PLANNING REVIEW CHECKLIST (Second Review Comments)

Subject Property: 2195 Vaughn Avenue NE

Reference No.: 23-111852-PLN

Sheet C1.1

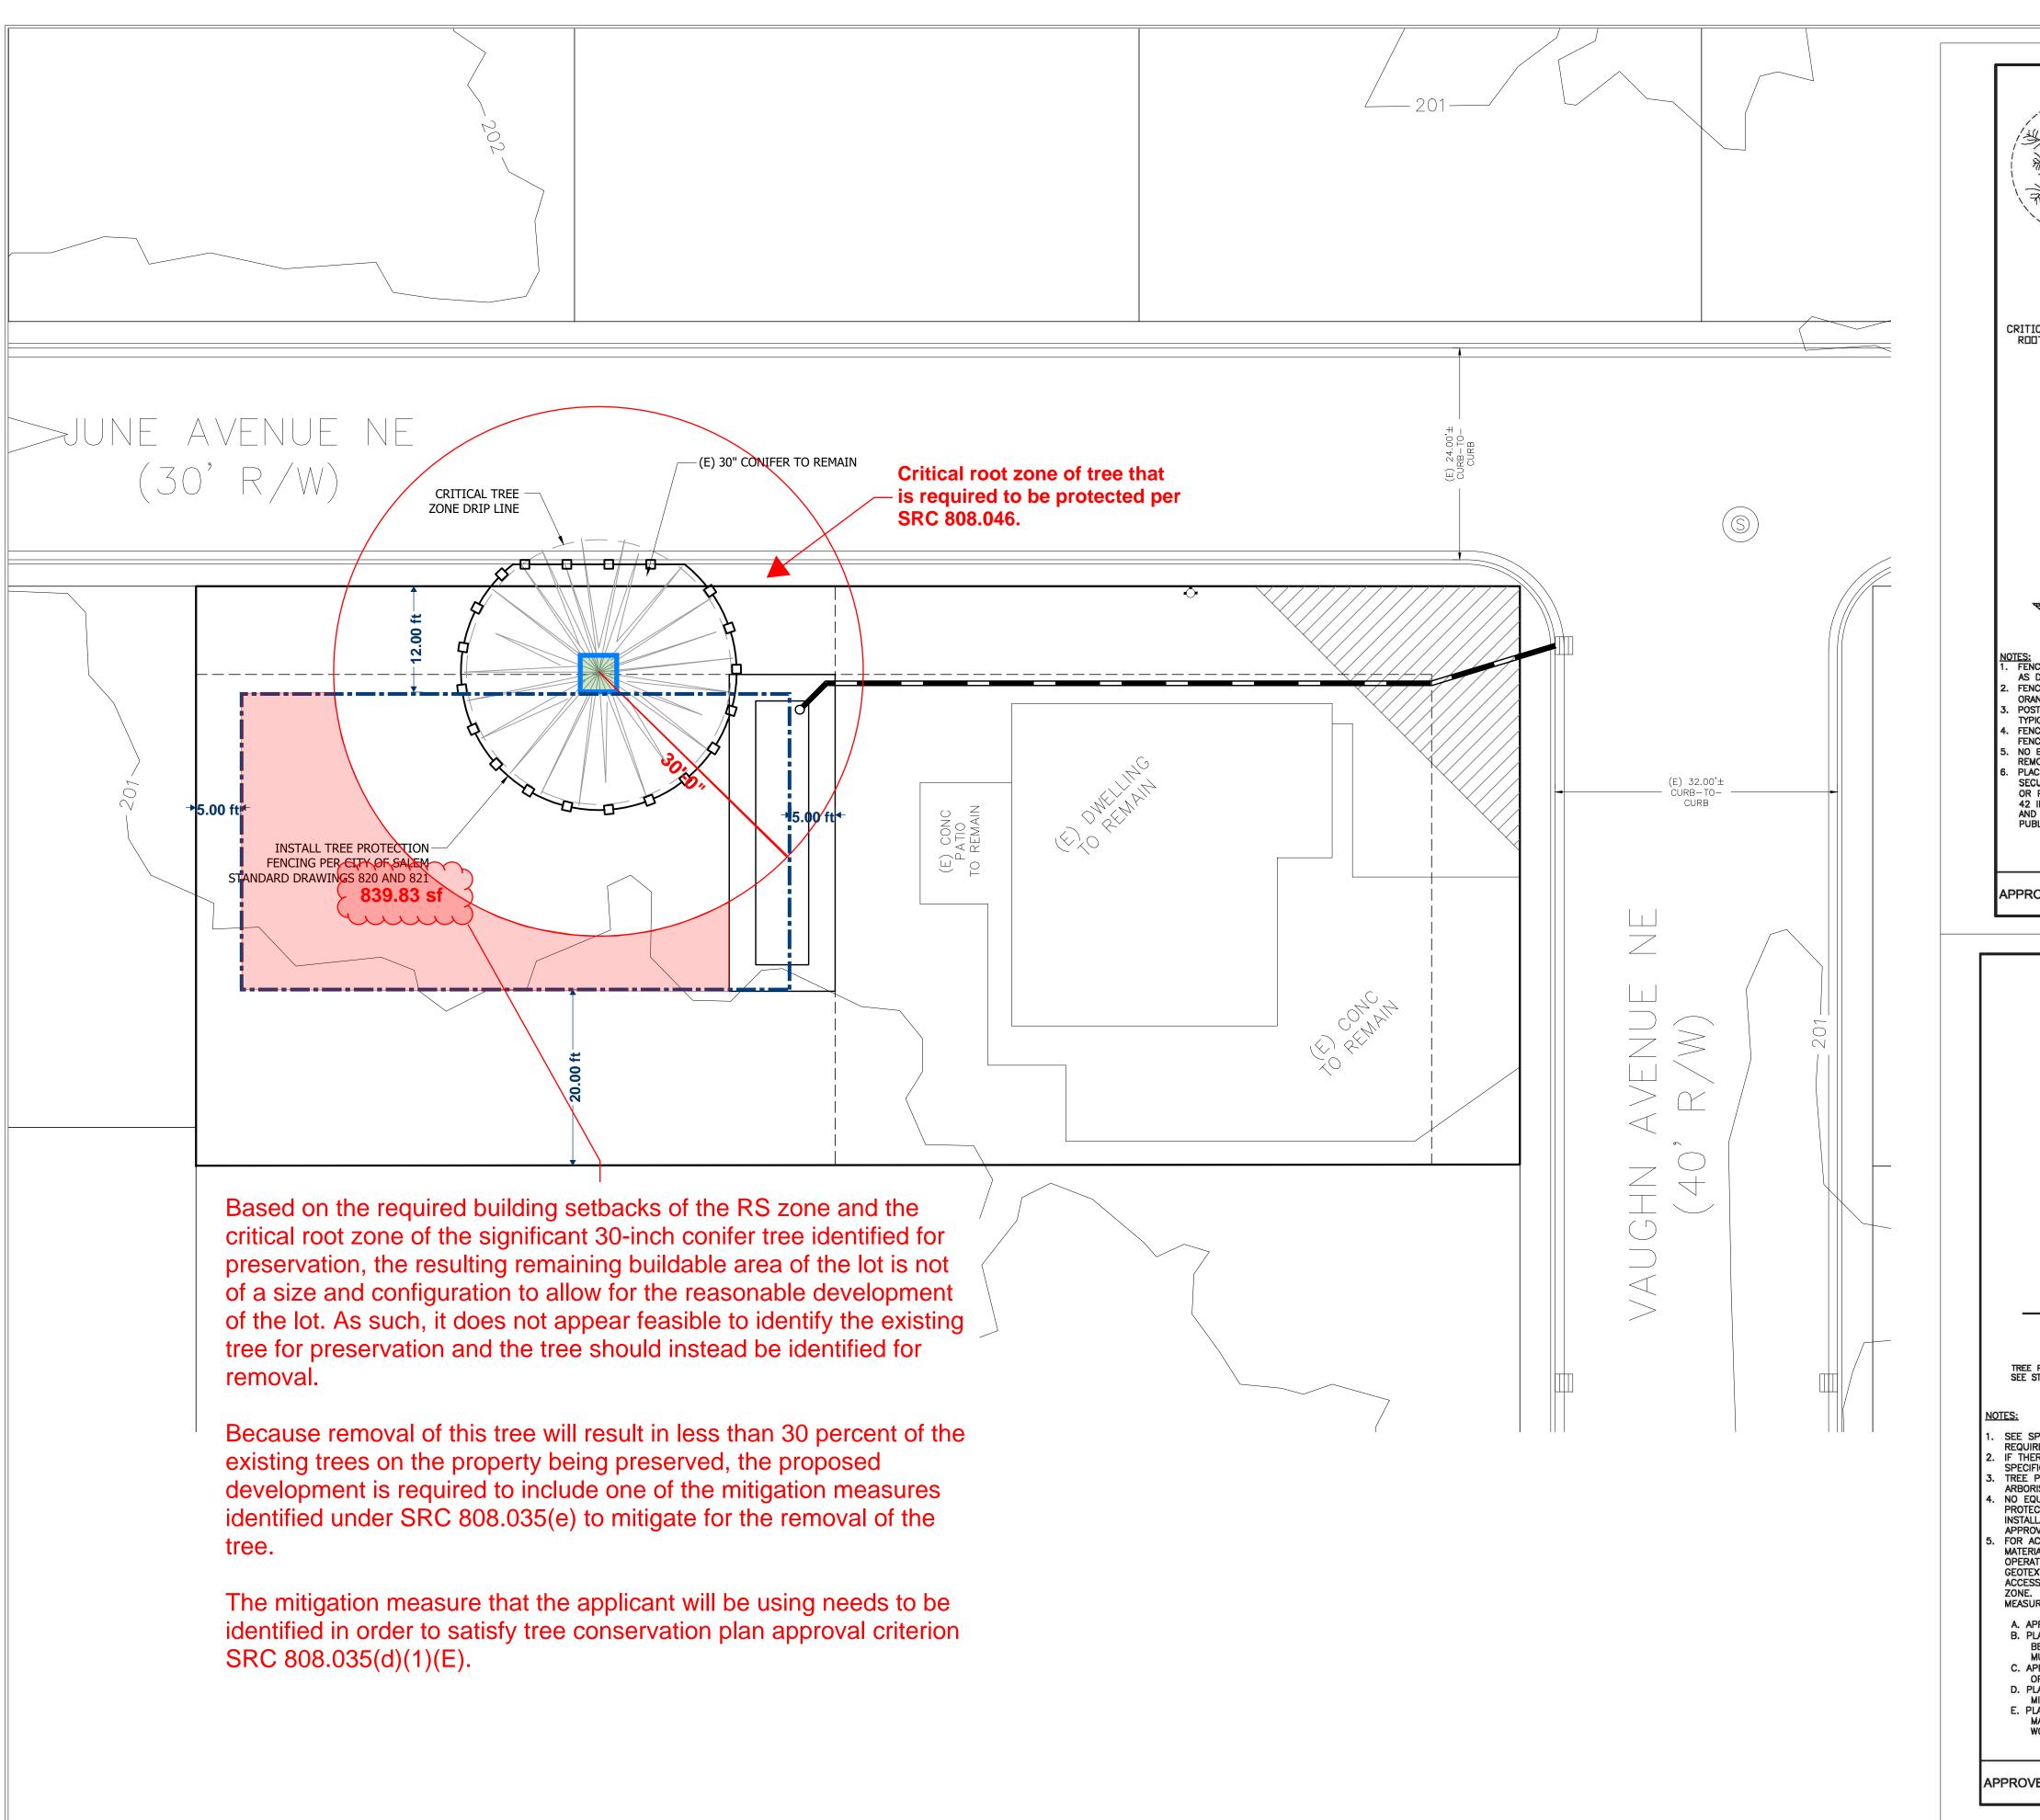
Item:	Description:
Tree Conservation Plan & Required Mitigation Measures	Existing Tree Identified for Preservation: In review of the tree conservation plan submitted it doesn't appear that the existing 30-inch conifer tree identified for preservation on the plan can actually be preserved based on the required building setbacks of the RS zone and the critical root zone of the tree. As illustrated by the comments included on the attached plan, it doesn't appear that proposed Parcel 2 can be feasibly developed when required building setbacks and the critical root zone of the tree are taken into consideration. As such, it doesn't appear feasible to identify the existing tree for preservation and the tree should therefore instead be identified for removal. Because removal of this tree will result in less than 30 percent of the existing trees on the property being preserved, the proposed development is required to include one of the mitigation measures identified under SRC 808.035(e) to mitigate for the removal of the tree. Tree Conservation Plan Mitigation Measures: Per SRC 808.035(e), when less than 30 percent of the trees on a property are designated for preservation under a tree conservation plan, any combination of one or more of the following mitigation measures shall be provided for each tree removed in excess of 70 percent:

(4) Open space lot. One or more lots within the development shall be designated as an open space lot planted at a minimum density of two trees for each tree removed. The replanted trees shall be of either a shade or evergreen variety with a minimum caliper of 1.5 inches. The lot(s) within the development that will be designated as an open space lot shall be specified in the conditions of the associated land division approval and shall be perpetually operated and maintained by a home owners' association.
	Per SRC 808.035(c)(4), when a tree conservation plan designates less than 30 percent of the trees on the property for preservation, an explanation is required to be provided with the tree conservation plan application identifying which of the above identified mitigation measures are proposed to be provided.
